SITE PLAN VIEW

STRUCTURAL DRAWINGS  
3170 MARKET St NE,  
SALEM, OR 97301

JOB No:  
24-1052  
SHEET No:  
S-1.0

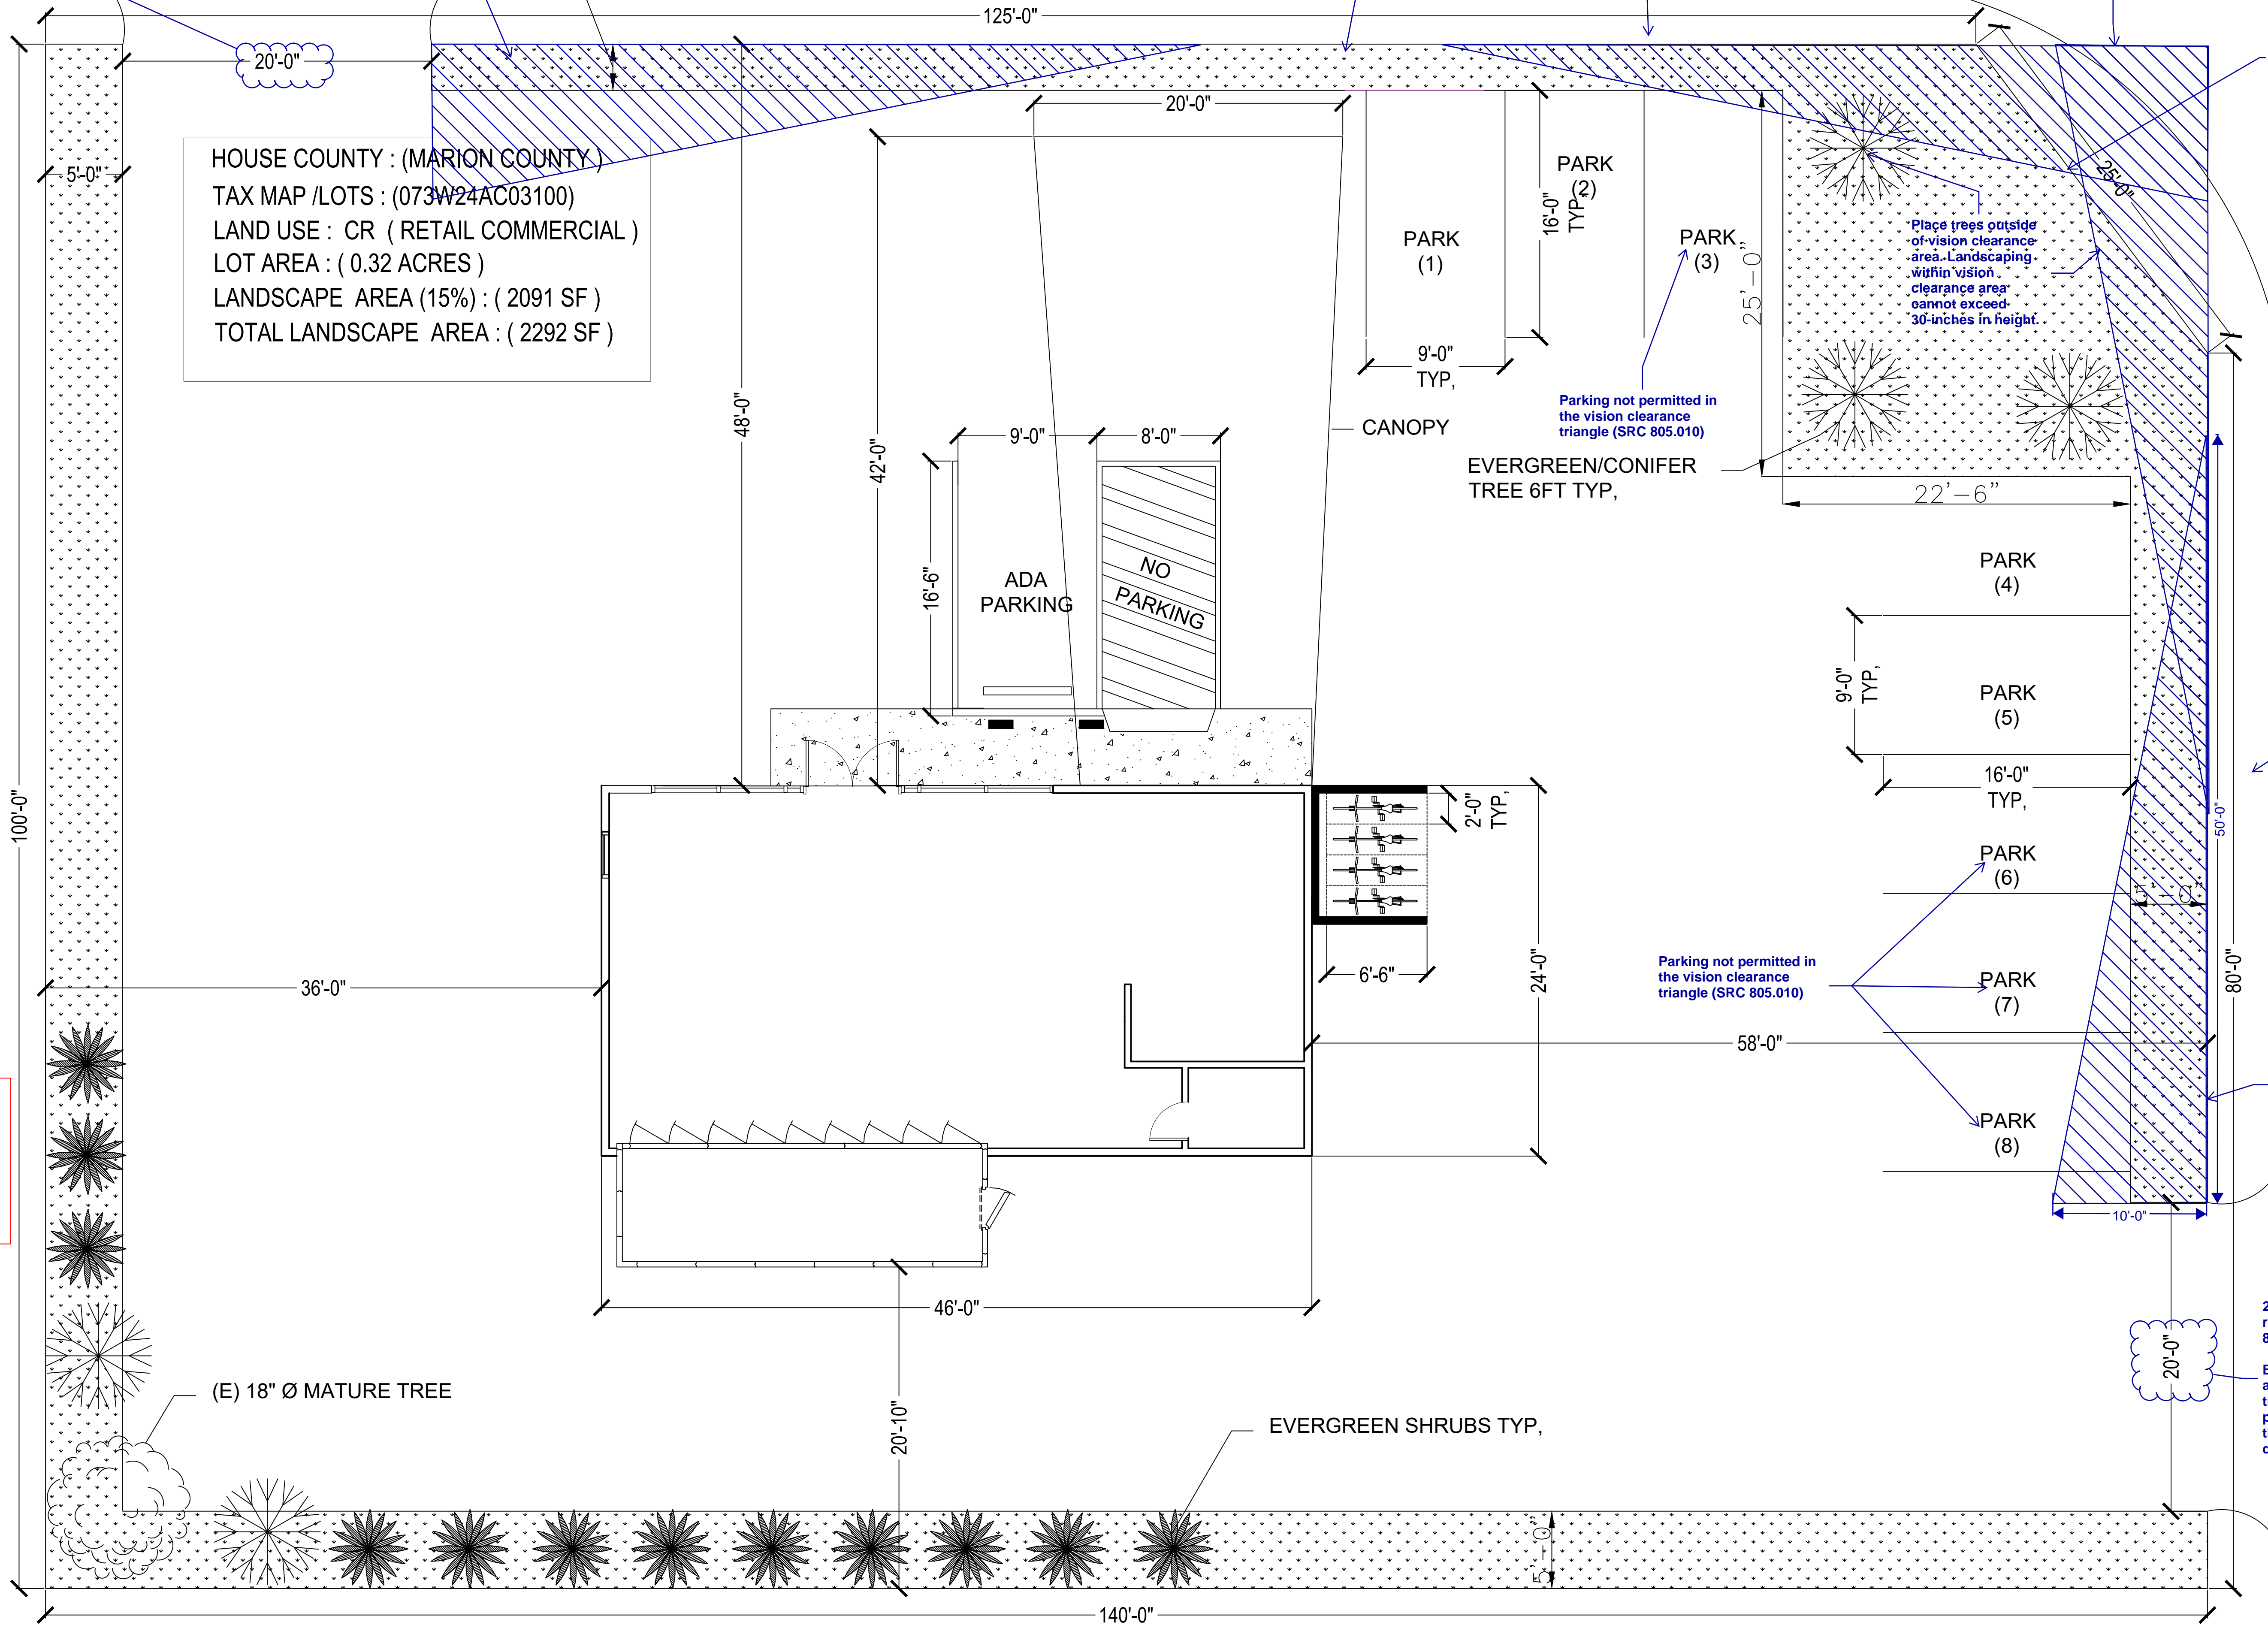
Existing approach appears to be wider than 20-feet. Are you proposing to reduce the width or is this a drafting error?

Recommend closure of this driveway approach. Current standards do not allow access onto arterial streets for corner lots (SRC 804.035(c)(2)). This would also allow you to move some of the parking within the vision clearance to this area.

Vision clearance area required (SRC 805.005(b)(2)). Show on site plan.

48-feet from Centerline Special Setback along Market Street NE. Show on Site Plan. New parking within this area will require a Removal Agreement (SRC 800.040(e)).

There is an existing approach approximately here that needs to be shown on the plans as permanently closed.

Vision Clearance area required at street intersection (SRC 805.005(a)(2)). Show on plans.

Property line not accurately shown at street intersection. Please show all current property lines.

Exempt from boundary street improvements (SRC 803.040(d)(3)). However, if new parking is added to the site, Transportation System Development Charges will be assessed for the change of use. The applicant is advised that Convenience Stores are relatively large trip generators. Please submit a TGE form in order to get an estimate of the System Development Charges that would be due at time of Building Permit.

Place trees outside of vision clearance area. Landscaping within vision clearance area cannot exceed 30-inches in height.

Parking not permitted in the vision clearance triangle (SRC 805.010)

Plans need to show existing street sidewalks. Appears some of the proposed landscaping will be within the ROW.

Vision clearance area required (SRC 805.005(b)(2)). Show on site plan.

22' minimum required (SRC 804.050(b)(2)). Existing approach appears to be wider than 20-feet. Are you proposing to reduce the width or is this a drafting error?
